## **ADDENDUM #2**

### **Rye City School District**

***Issued: 2021-02-05***

**This Addendum No. 2 forms part of the Contract Documents and modifies the original bidding documents dated, January 19, 2021.**

**EXTERIOR DEMOLITION ELEVATIONS**  
**PROJECTS 1 & 4**  
SEAL & SIGNATURE: \_\_\_\_\_ DATE: 02/13/20  
PROJECT No.: 9200  
DRAWING BY: Author  
CHK BY: \_\_\_\_\_ Checker  
DWG No: D2-201

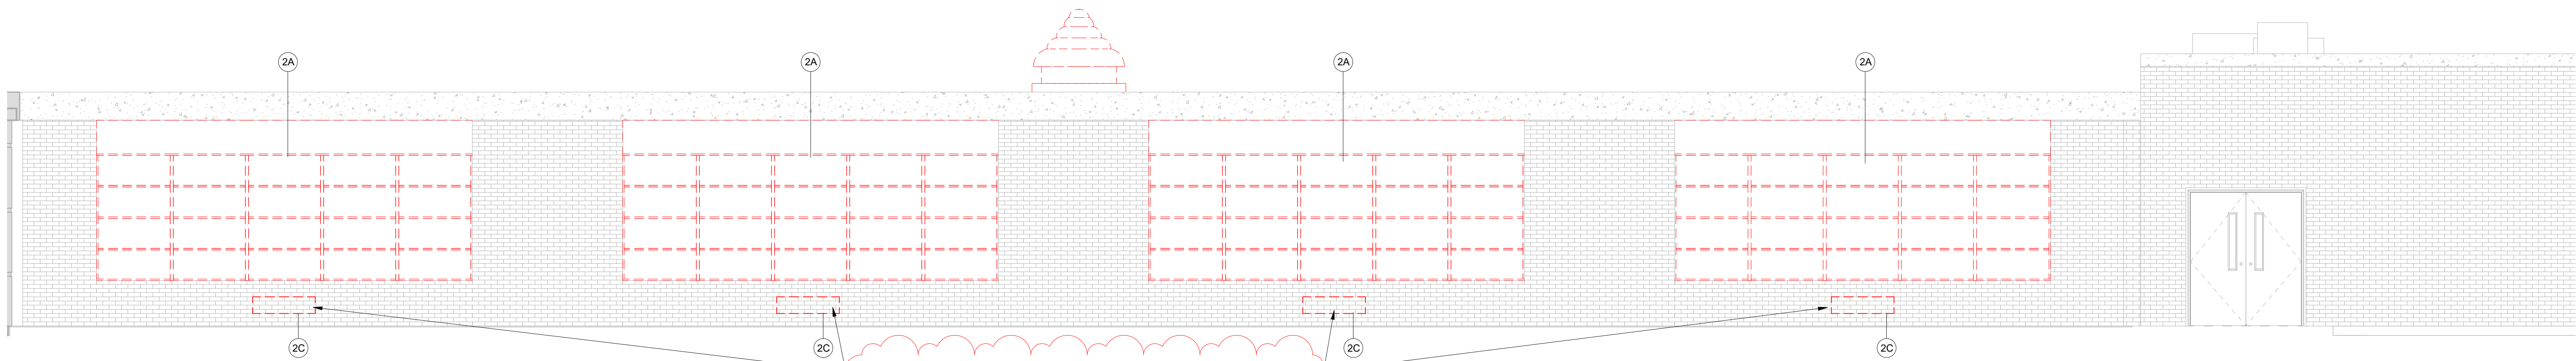
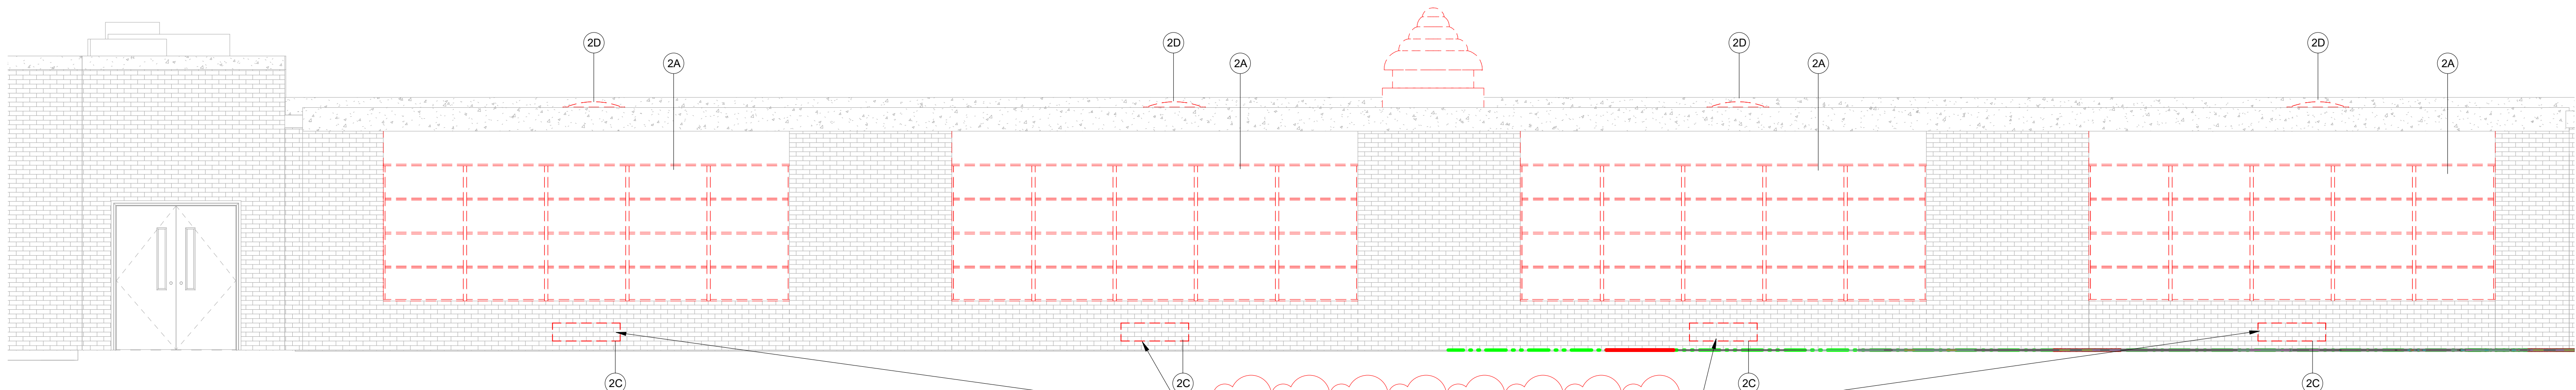
1. D2-201:
  - a. Note added for exterior infill wall where existing louvers will be removed after the demolition of existing unit ventilators.
2. A2-512:
  - a. Note added for exterior infill wall where existing louvers will be removed after the demolition of existing unit ventilators.

AFTER MECHANICAL CONTRACTOR HAS REMOVED THE EXISTING UNIT VENTILATOR. REMOVE EXISTING LOUVER AND PREPARE OPENING FOR NEW MASONRY INSTALL, 4" CONCRETE BLOCK, WATERPROOF BLOCK WITH FLASHING EXTEND TO FACE OF BRICK WITH DRIP EDGE, 2" INSULATION, 2" AIR SPACE AND FACE BRICK TO MATCH THE EXISTING BRICK

SEAL & SIGNATURE | DATE: 01/19/21  
PROJECT No: 9200  
DRAWING BY: Author  
CHK BY: Checker  
DWG No: D2-203

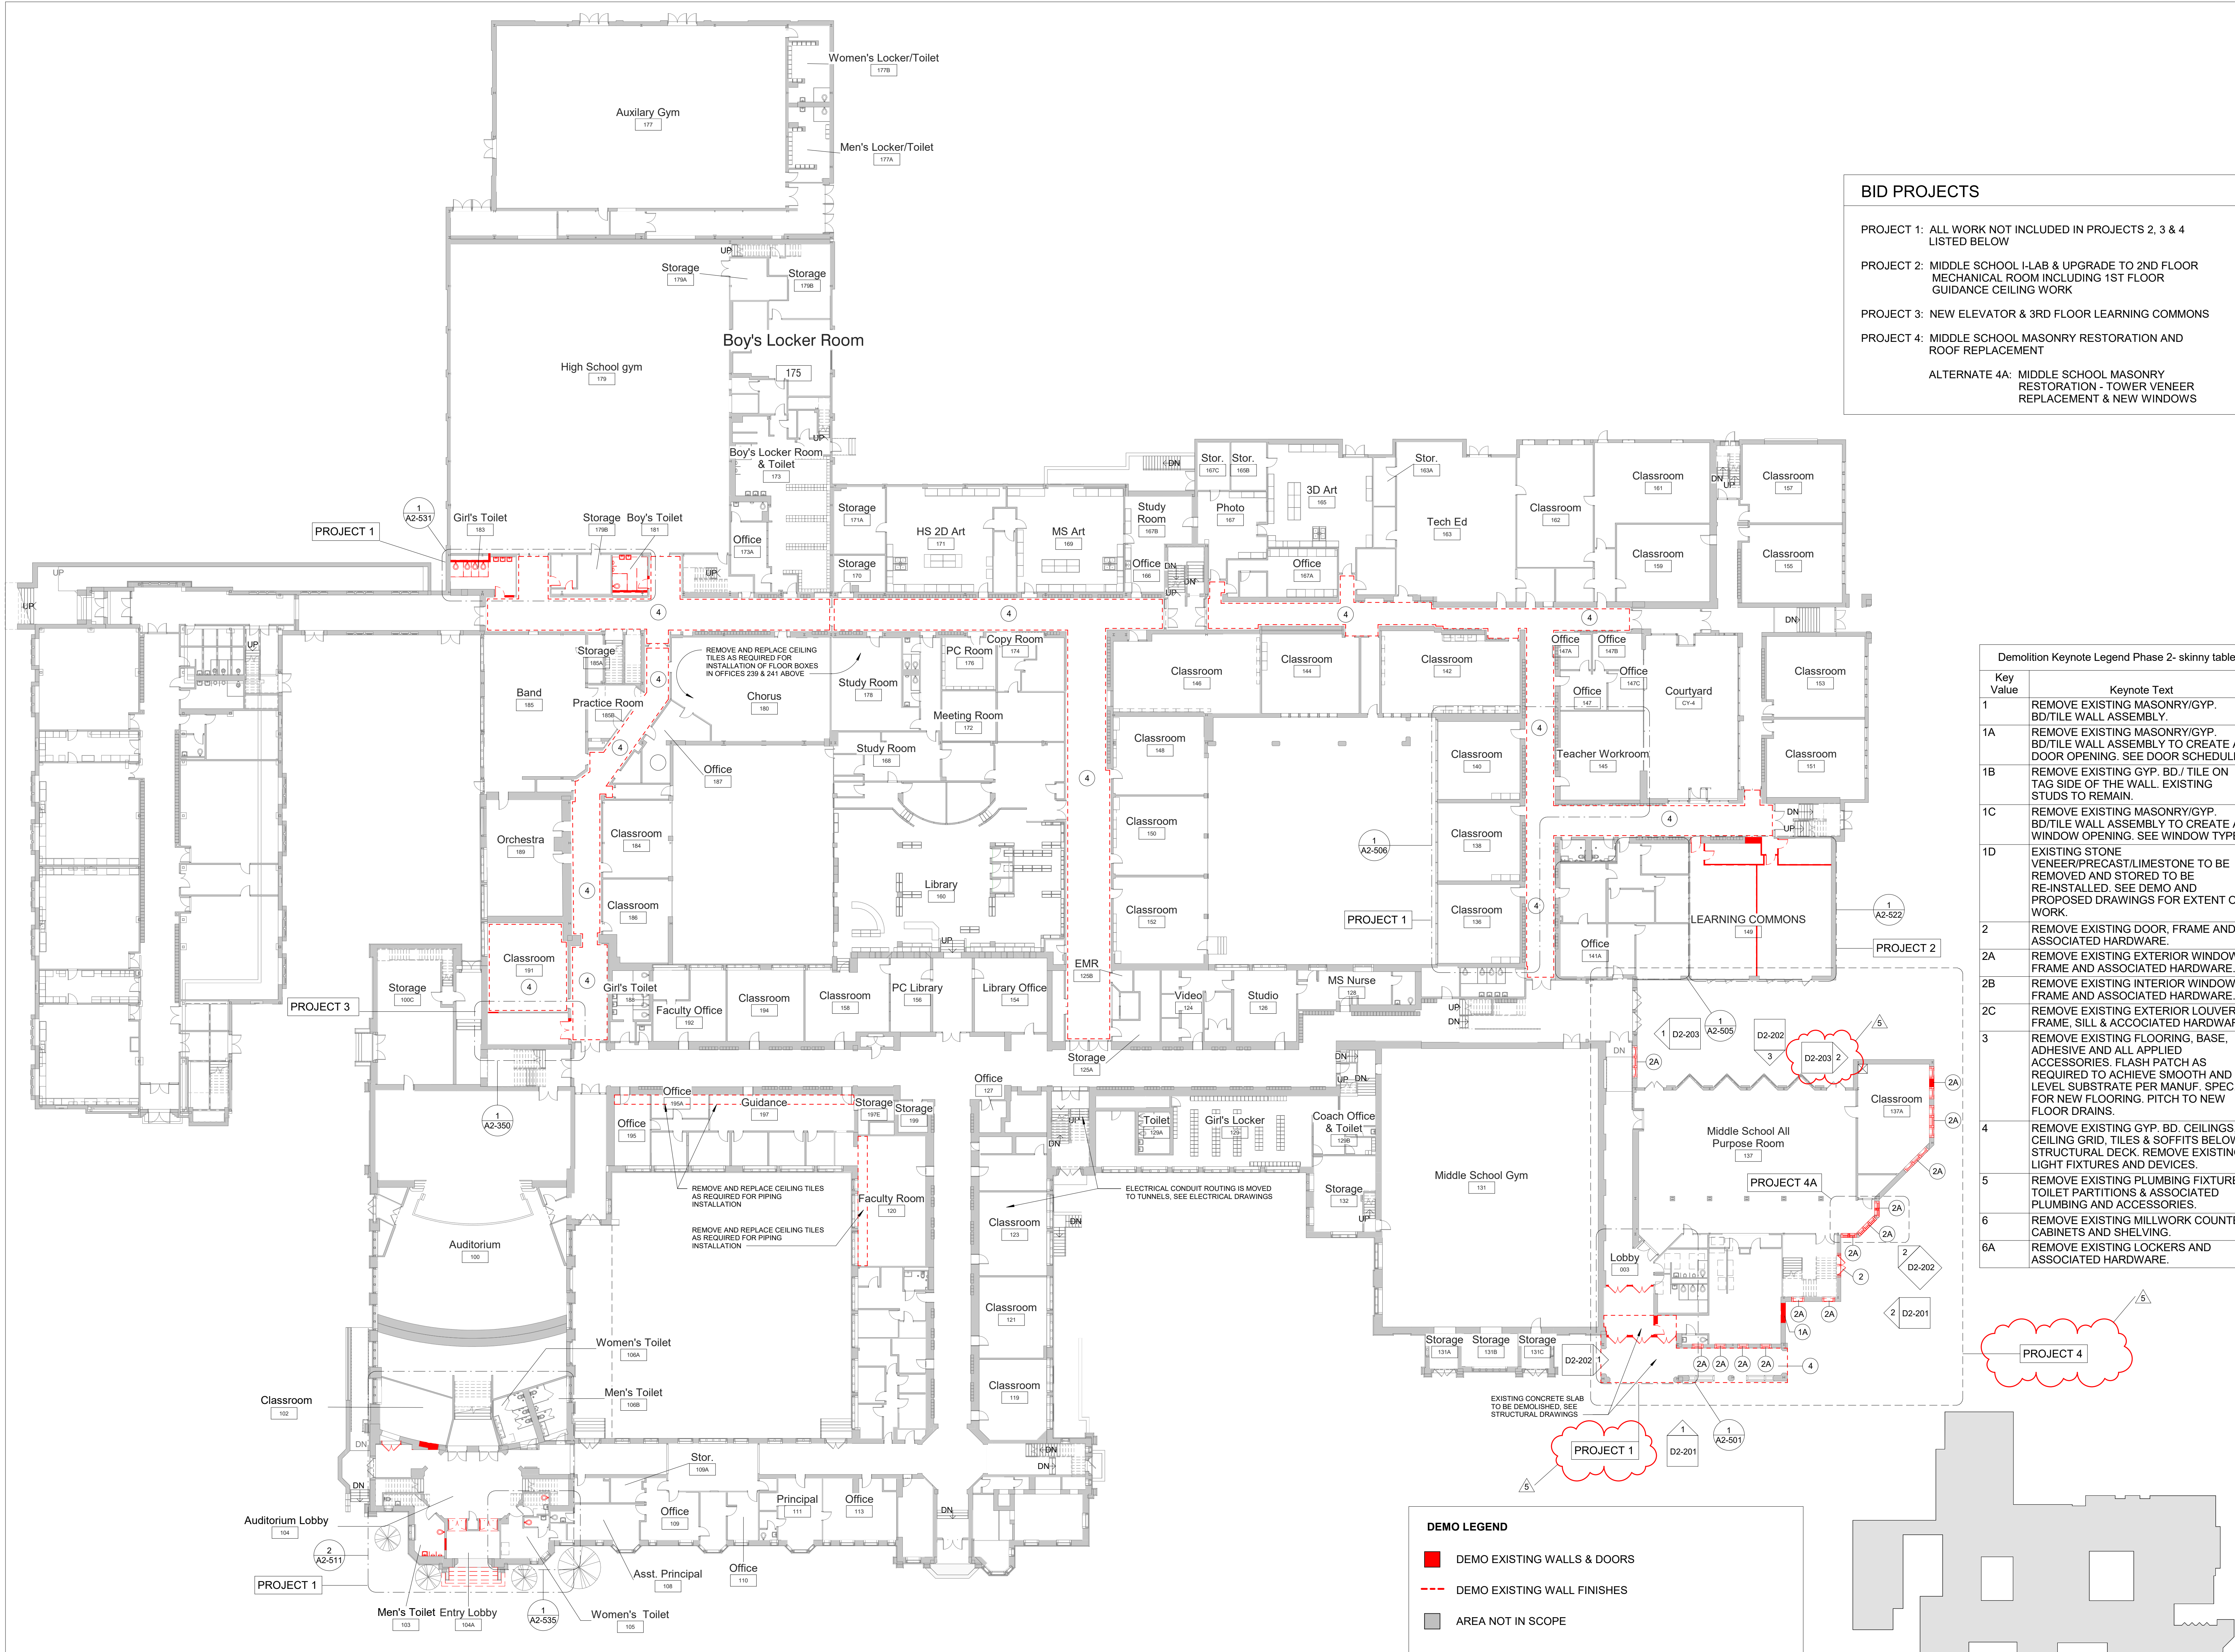
1. D2-101:
  - a. Projects 1 & 4 areas updated.
  - b. Elevation tag for 2/D2-203 added.
2. D2-102
  - a. Projects 1 & 4 areas updated.
  - b. Elevation tag for 2/D2-203 added.
  - c. Note added for ceiling removal and replacement outside of Classroom 209.
3. D2-203
  - a. Elevation 2/D2-203 added
4. A2-101
  - a. Projects 1 & 4 areas updated.
  - b. Elevation tag for 2/A2-203 added.
5. A2-102
  - a. Projects 4 area updated.
  - b. Elevation tag for 2/A2-203 added.
  - c. Location for openings clarified along elevation 1/A2-203.
6. A2-115
  - a. New wood blocked noted at parapets.
